ANACORTES PLANNING COMMISSION

**Anacortes High School Replacement & Renovation,
CUP-2015-0006**

Agenda Item: CUP-2015-0006

Subject: Anacortes High School Replacement & Modernization CUP & Variance request

1 SITE PLAN
SCALE: 1" = 50'-0"

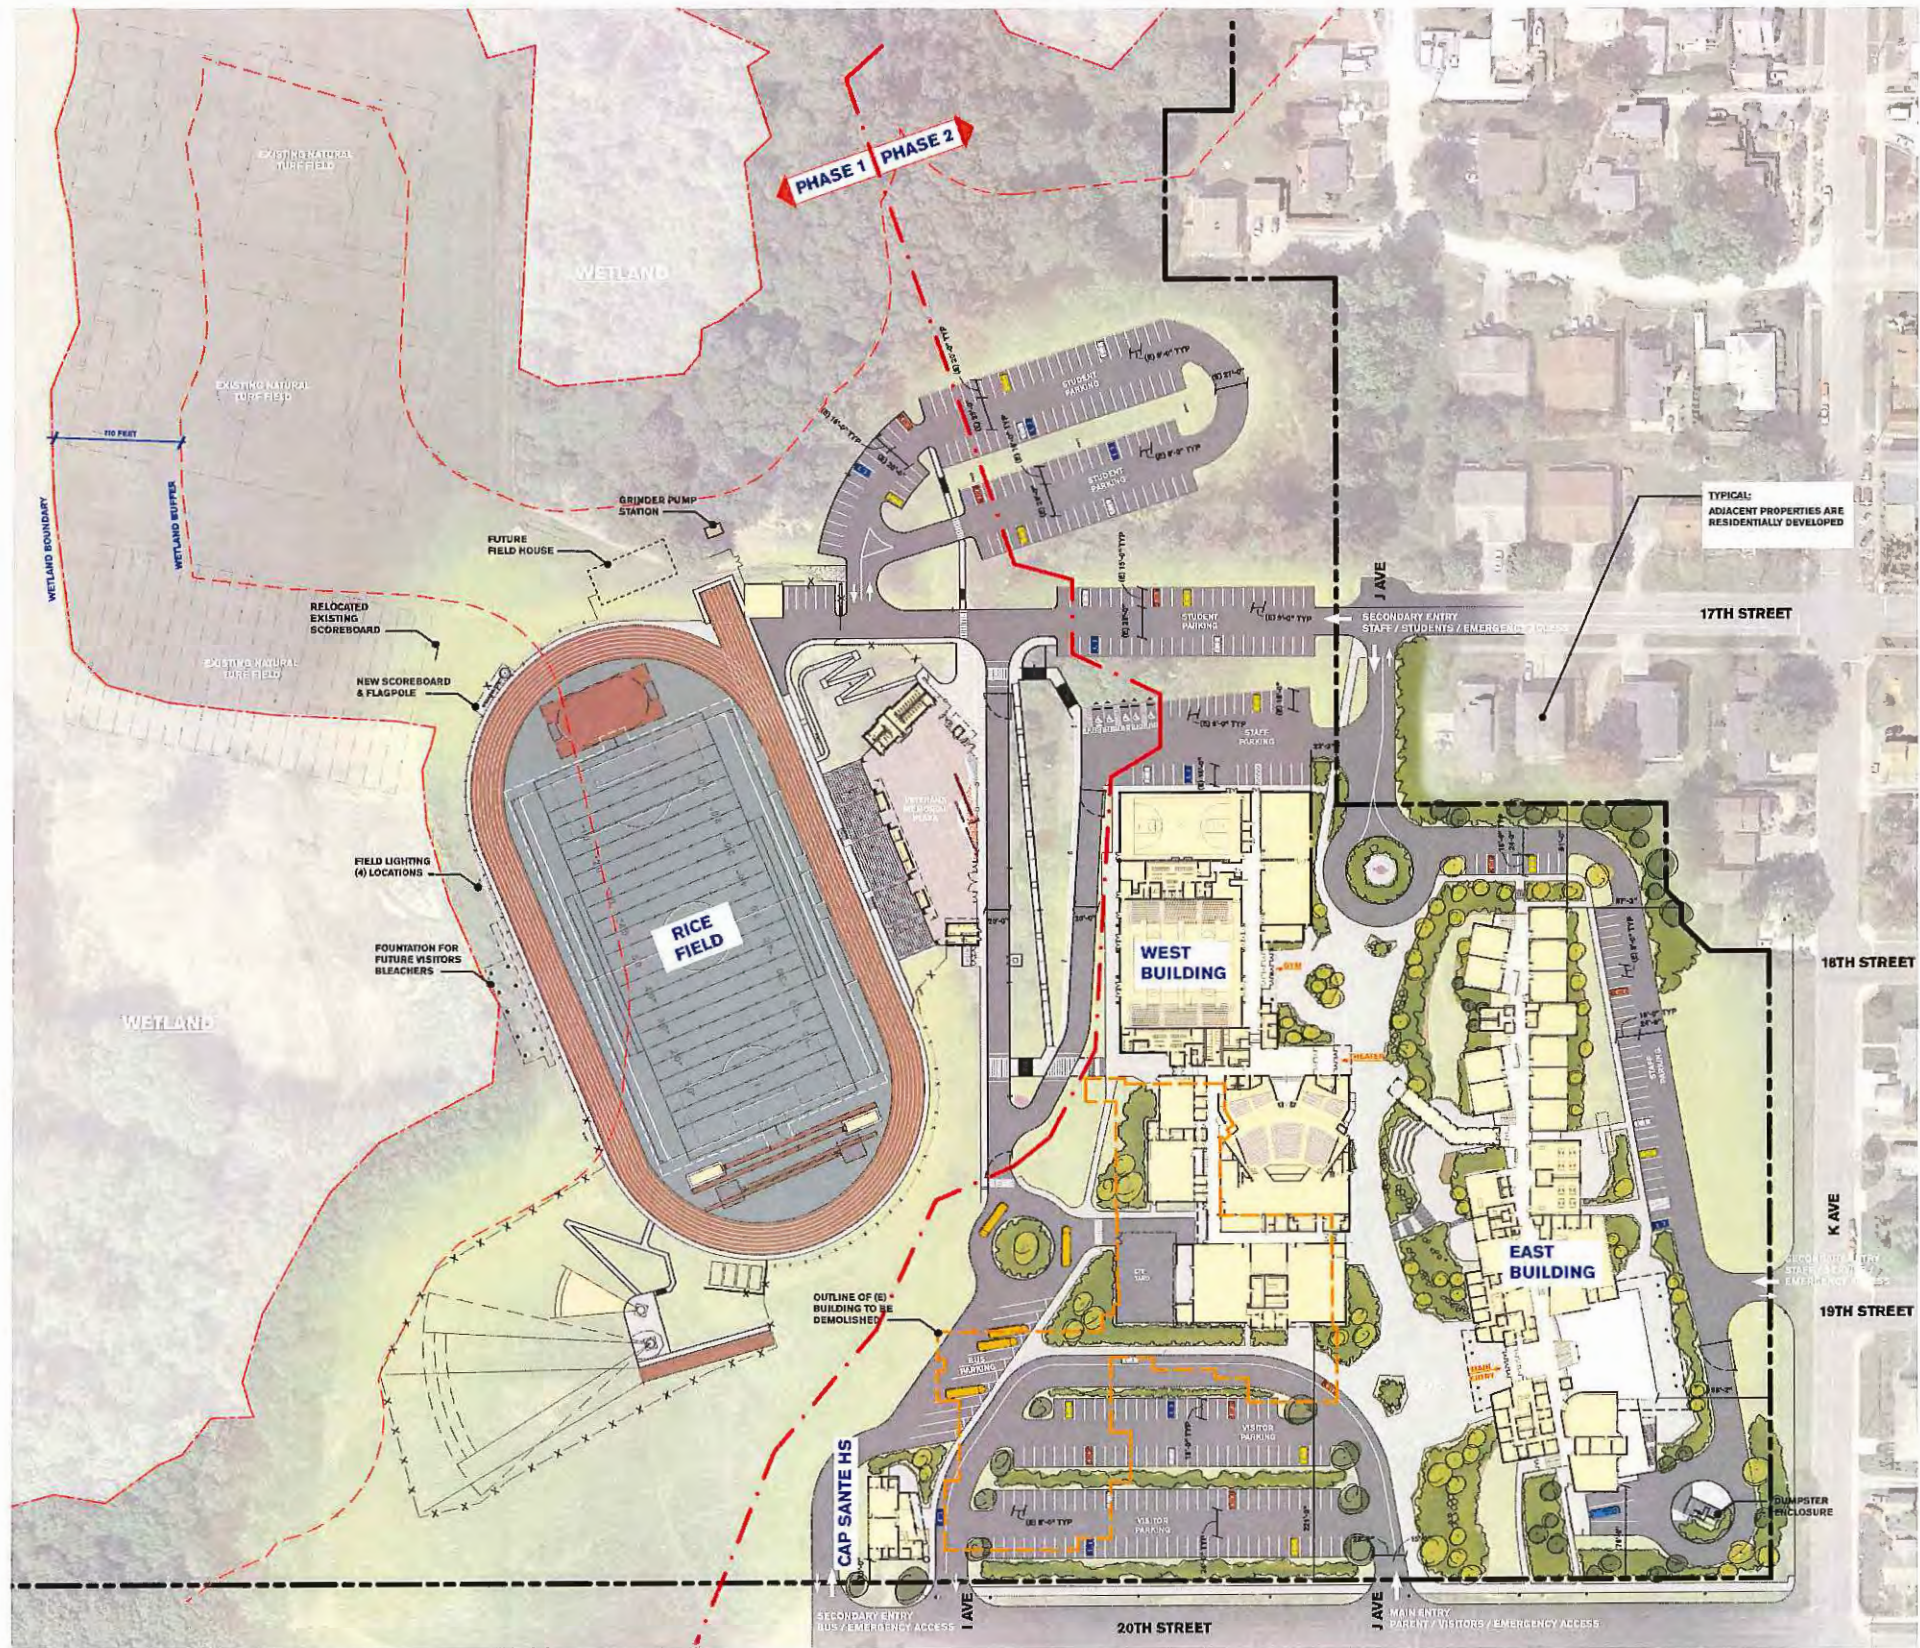
- a. *Cultural Resource Report was received from Jacob's and four copies are included for your use.*
3. The edges of the wetland shown in the critical area report /wetland report do not appear to precisely match those show on Sheet CUP.01. Please correct accordingly.

5. The Plaza will need to be drive-able by fire apparatus.
 - a. A 20-foot wide (minimum) drivable access will be provided through the plaza for emergency vehicles. This is delineated on drawing Sheet CUP.01.*

11. Please show the zoning lines for the Public Use and R3 Zoning Districts on the plans for the subject property and label accordingly.
- a. *Included on the revised drawing Sheet CUP.01.*

- a. *Included on the revised drawing Sheet CUP.01.*
- b. *Showers are provided for staff and students within the proposed facility.*
17. Please confirm that back in parking of school busses is proposed as is shown on Sheet CUP.O1.

- a. *Edges of the wetland have been modified on the survey and adjusted on our drawing CUP.01. ATSI to correct the delineation in their report.*
4. Although, the traffic plan does have some discussion regarding off-street parking, please provide a concise account as to how you comply with Chapter 17.46 of the Anacortes Municipal Code regulating off-street parking. How many off-street parking spaces exist? How many spaces are proposed? How many off-street parking spaces are required per AMC 17.46.020? Additionally, what are the stall dimensions?
